CS Memorandum No. 1694

Subject: Configuration Management Board Meeting No. 168

SUBJECT: Configuration Management Board Meeting # 168 – Rev. No. 0

Contract No. 1252 - Tunnel
 Comparison Sheet:
 COR 082 Estimate:
 MOS 20" Low Psi Water Piping vs AWSS Piping Re-route:

CL-18060	REVISION
WD-403	0
SHEET NO.	141

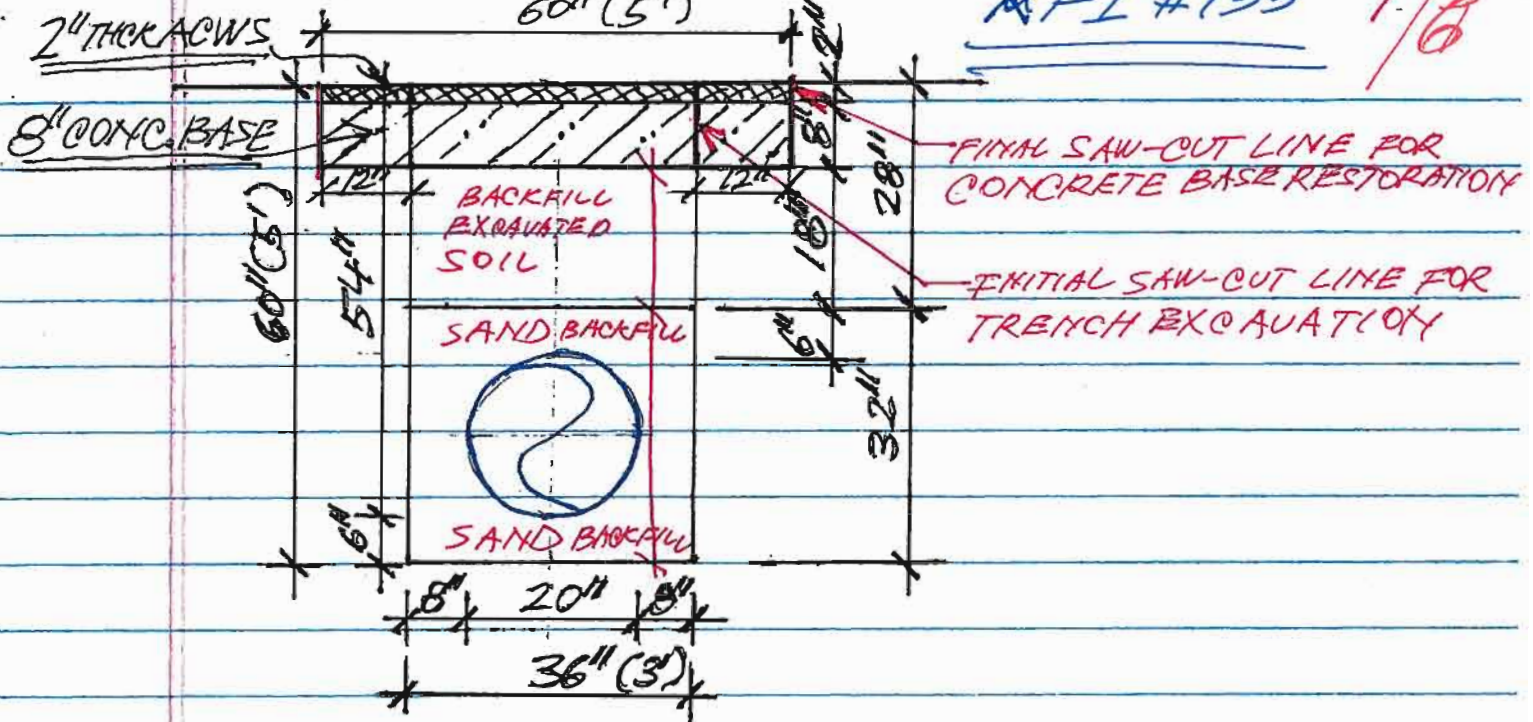
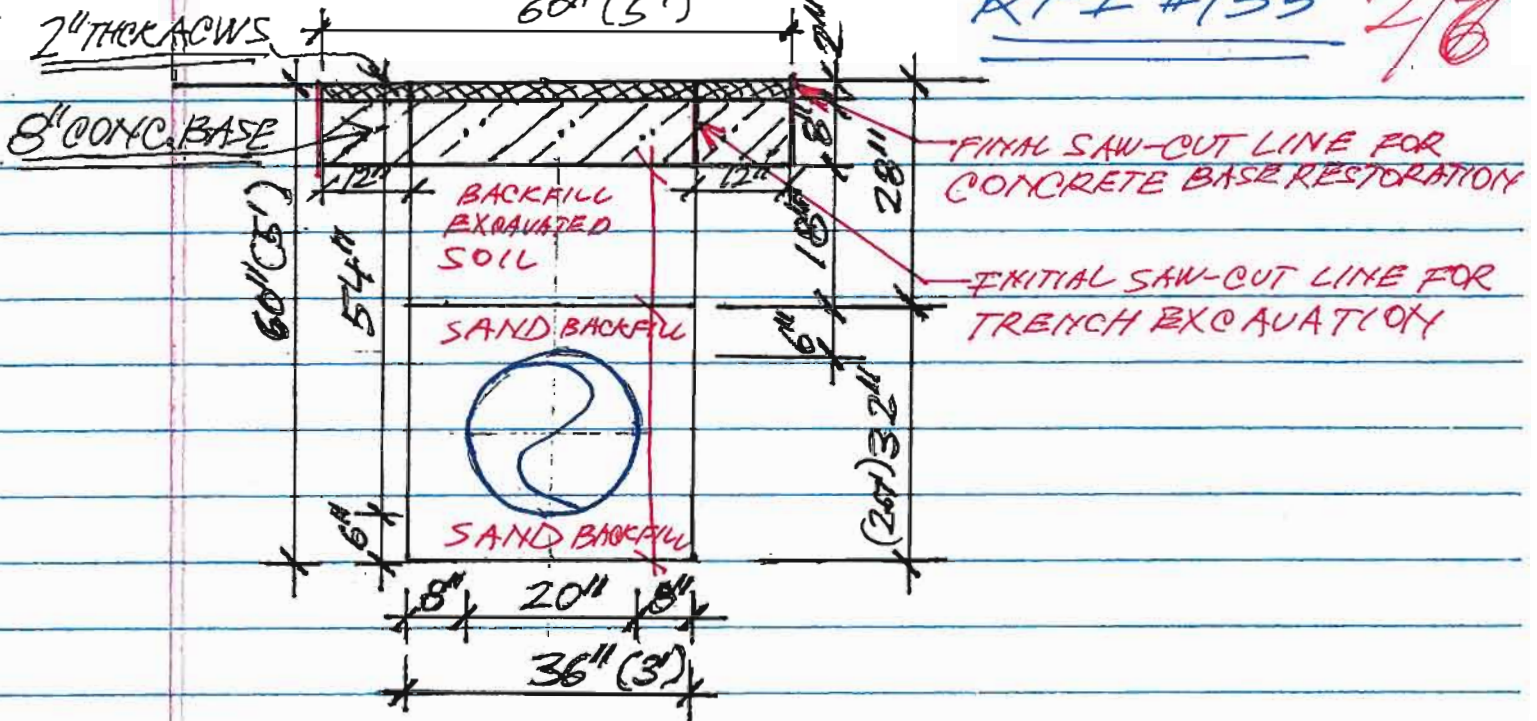
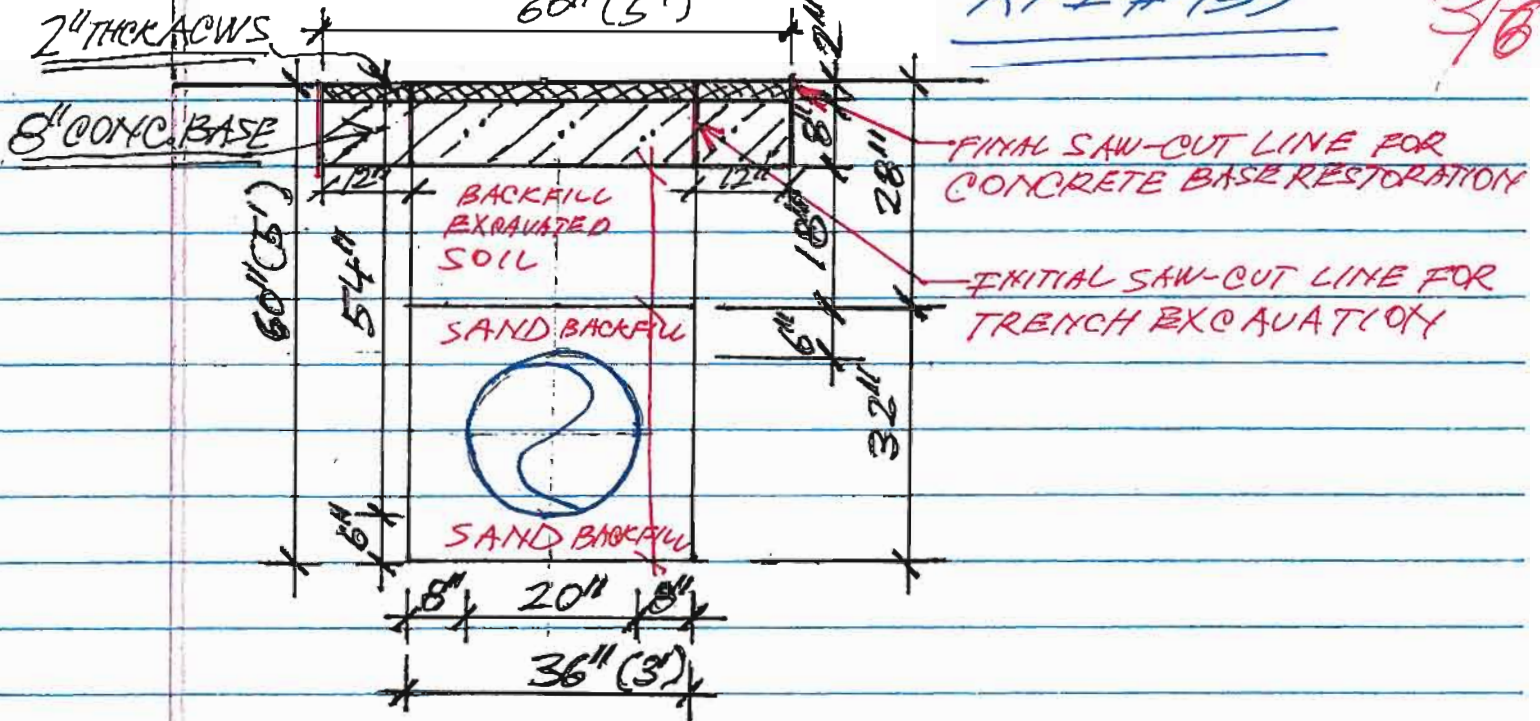
Contract Drawing WD-404 & WD-404 shows 20" Low pressure water line cutting through an area in the intersection of 4th Street & Folsom Street where the joint trench is in the way. BIHJV's subcontractor, Synergy Project Management, with SFMTA's concurrence installed the water line per a configuration which resulted in approximately 65 feet less water line to be installed. SFMTA requested credit CO to eliminate 65' of water line. Upon exposing the existing 20" waterline at the south headwall of MOS, the Contractor encountered a conflict between the proposed 16" AWSS, the proposed re-routed 20" waterline and the existing 6" PG&E gas line. These three utilities cross at multiple locations at about the same depths. The preferred resolution would require the 20" waterline to be vertically rerouted cross over the 16" AWSS and the 6" PG&E gas line. The additional New Work resulting from the utility conflicts is listed below. The scope of work was broken into the following meaningful activities:

TAKE OFF 65 FEET OF 20" WATERLINE
PAVEMENT RESTORATION
 60" (5')

COR 082 - Utility Conflicts @ MOS S Headwall

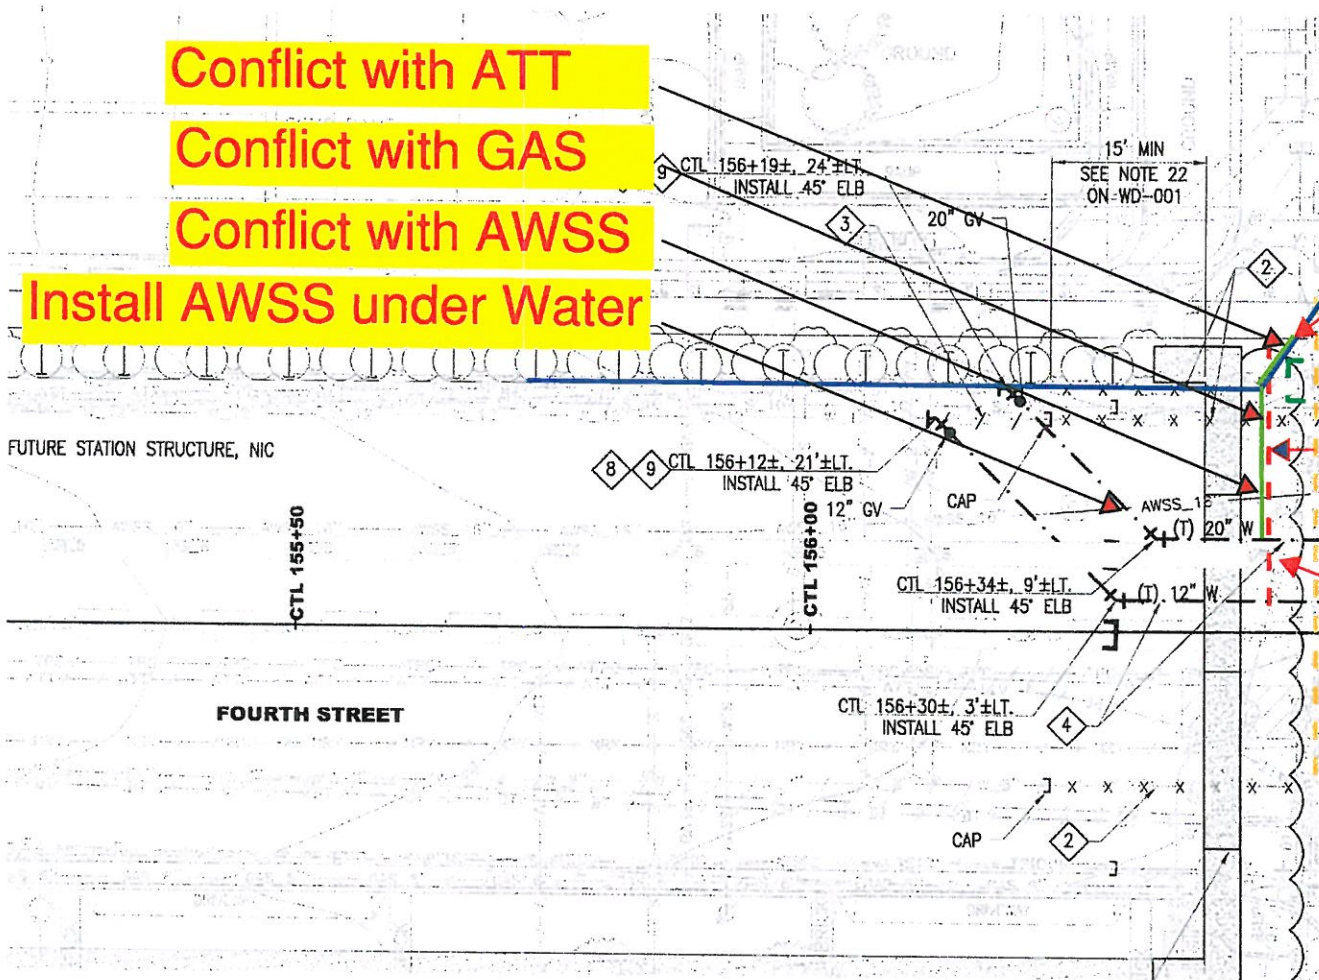
During installation of the waterline, per the revised alignment, the close proximity of existing utilities (see attached field sketch 1252-085) required that the Contractor utilize hand excavation methods and additional shoring. The Contractor's is claiming an additional two (2) days of work related to these additional excavation activities.

The revised waterline alignment crossed an AWSS line at two (2) locations as opposed to the one (1) crossing shown in the original alignment. Additionally, the new alignment was in close proximity to a new AWSS trench excavated by the Contractor. As a result the Contractor was required to utilize hand excavation methods and additional shoring in order to protect the existing facilities. Additionally, the second crossing required the installation of an additional bell and stop collar. The Contractor's is claiming two (2) additional days of work related to these additional AWSS installation activities.

- Additional AWSS Installation Work: The Contractor was required to install an AWSS line as part of the Contract work, however, due to the new alignment of the 20" waterline a utility there was a conflict between the two lines (see attached field sketch 1252-085). Detail 3 of drawing WD-004 indicates how the Contractor is to install a utility crossing; however, the Contract Documents are not explicit on how payment is to be made for a utility crossing. As such, the RE recommends compensating the Contractor for installation of additional materials required for the utility crossing of the AWSS.

Recommendation: Accept partial justification of Merit for COR 082, for additional work required to reroute a 20" waterline, per the SFMTA's response to Request for Information (RFI) No. 155. Recommend compensating the Contractor for 3 additional days of work and the additional material cost for the additional AWSS fittings to complete the waterline at the new alignment. A credit is also due for 65 feet of 20" waterline not required to be installed per the original alignment required by Contract. There is no time extension requested or recommended for this work.
